**CITY OF CORPUS CHRISTI
ENGINEERING SERVICES
CHANGE ORDER**

CHANGE ORDER NO: 4 3	CHANGE ORDER DATE: 1/13/2021 01/21/2021
PROJECT: (RE-BID) Park Road 22 Lift Bridge (Bond 2004)	PROJECT NUMBER: 6281
CONTRACTOR: Haas-Anderson Construction	ORIGINAL CONTRACT TIME: 639 CD's
ENGINEER: Urban Engineering

REQUEST FOR INFORMATION

PROJECT NO: 6281
PROJECT NAME: Park Road 22 Bridge
ENGINEER: Urban Engineering

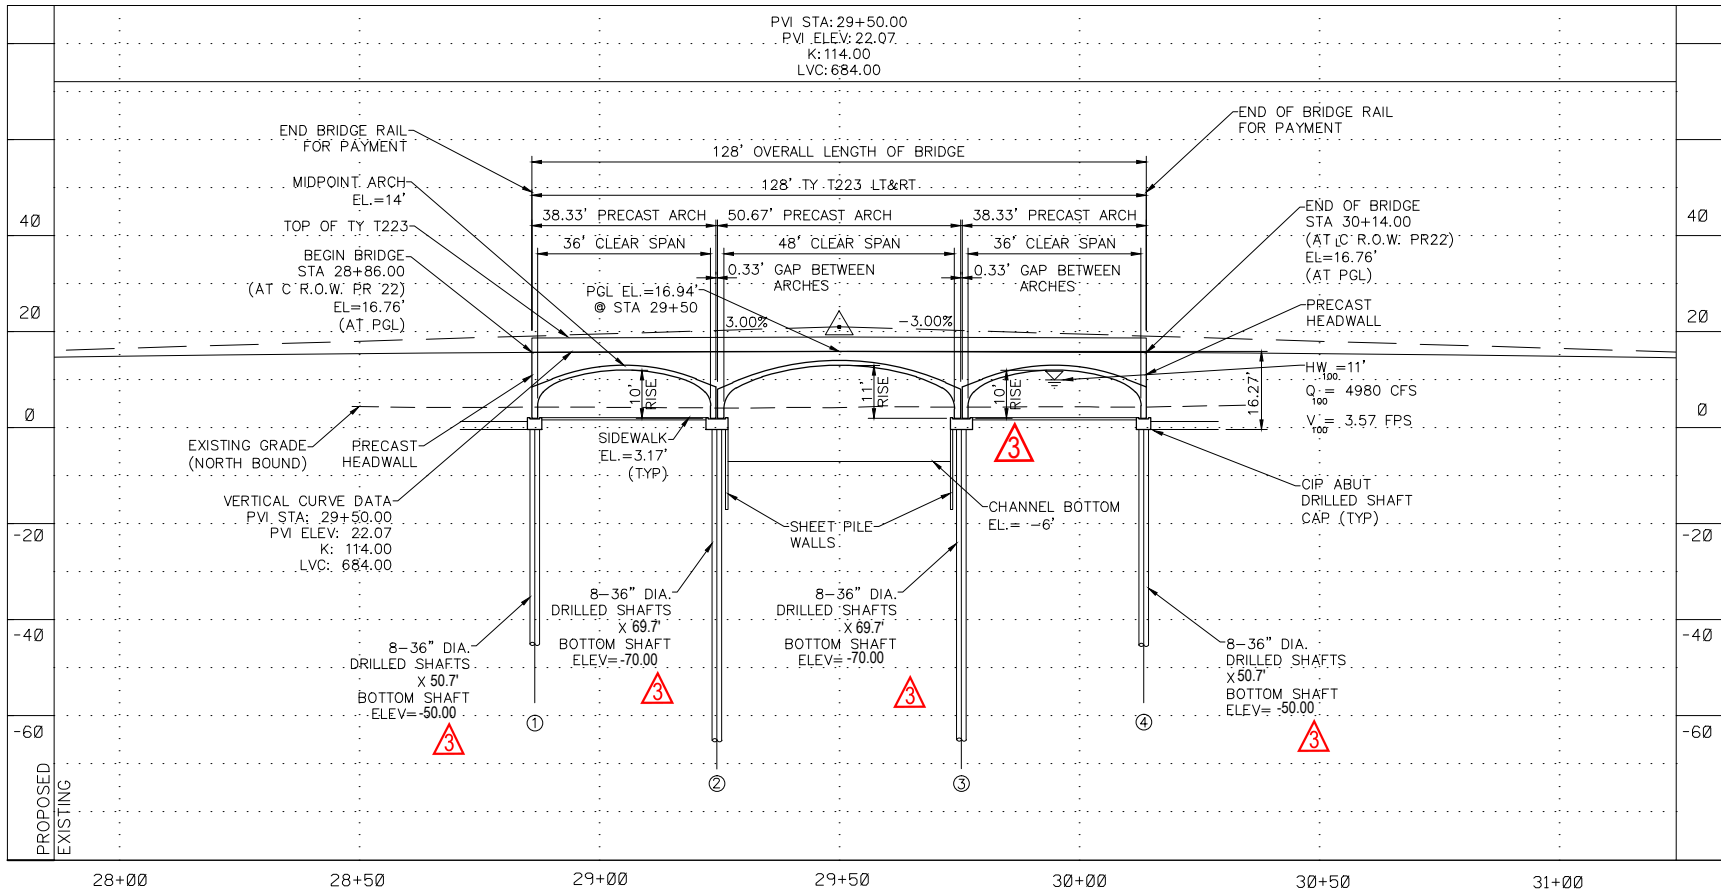
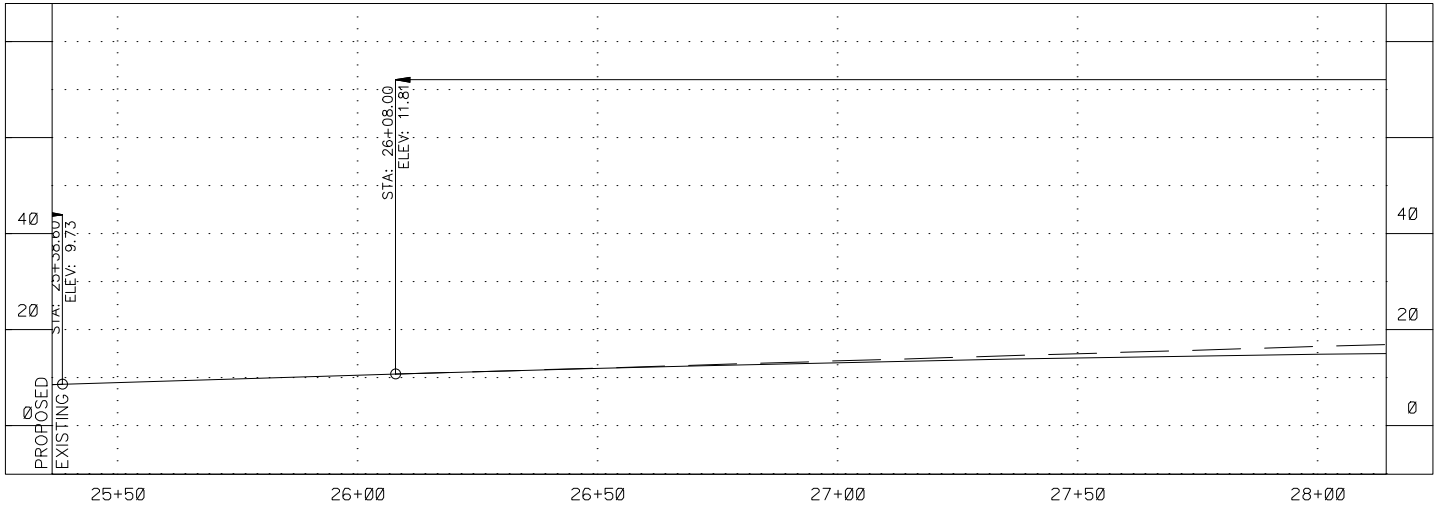
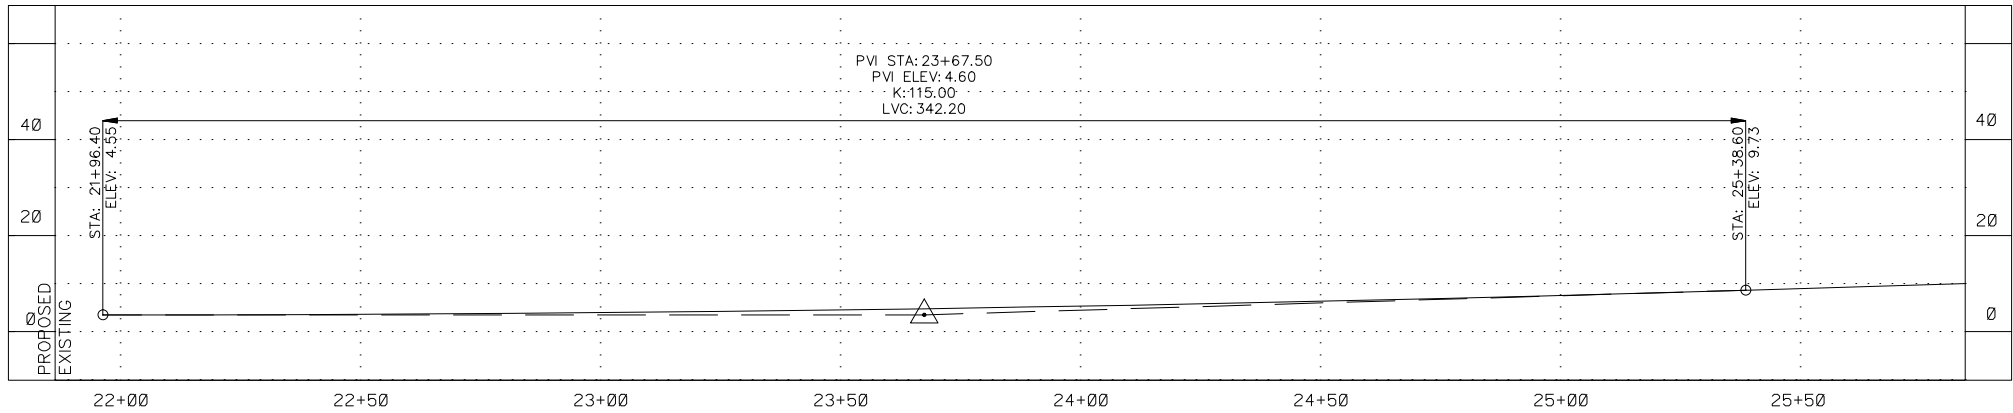
As shown on plan sheets 110 & 112, the interior bent drilled shaft lengths are 69.7 LF and abutment drilled shaft lengths are 50.7 LF. As shown on plan sheet 117, there are 36 interior bent drilled shafts and 32 abutment drilled shafts. This equates to a total drilled shaft length of 4,131.6 LF. The plan quantity is 3,532 LF.

At one point in the design phase of the project piling lengths were adjusted to reduce settling. The quantities provided by the structural engineer at final bid were not updated. There is no real excuse for this mistake, but the multiple times the project was stopped and restarted, changed and re-bid from 2011 to 2020 likely contributed to the mistake. Although the shaft lengths were shown correctly in the plans, the quantity was not correct. I believe the contractor's request for the change order is reasonable. Rhodes C Urban, P.E.
City of CC agrees with engineers response.
Ruben Barrera Sr. Project Mgr. 1/13/2021

Hi Chip. The total quantity is 4,131.6 LF. The plan quantity figure of 3,532 LF was calculated and provided in the original drawing set in 2014. Over the course of several drawing updates and changes, occurring over several years, the quantity was increased to 4,131.6 LF. It appears to be an oversight that those changes didn't get reflected in the quantities which were included in the specifications.
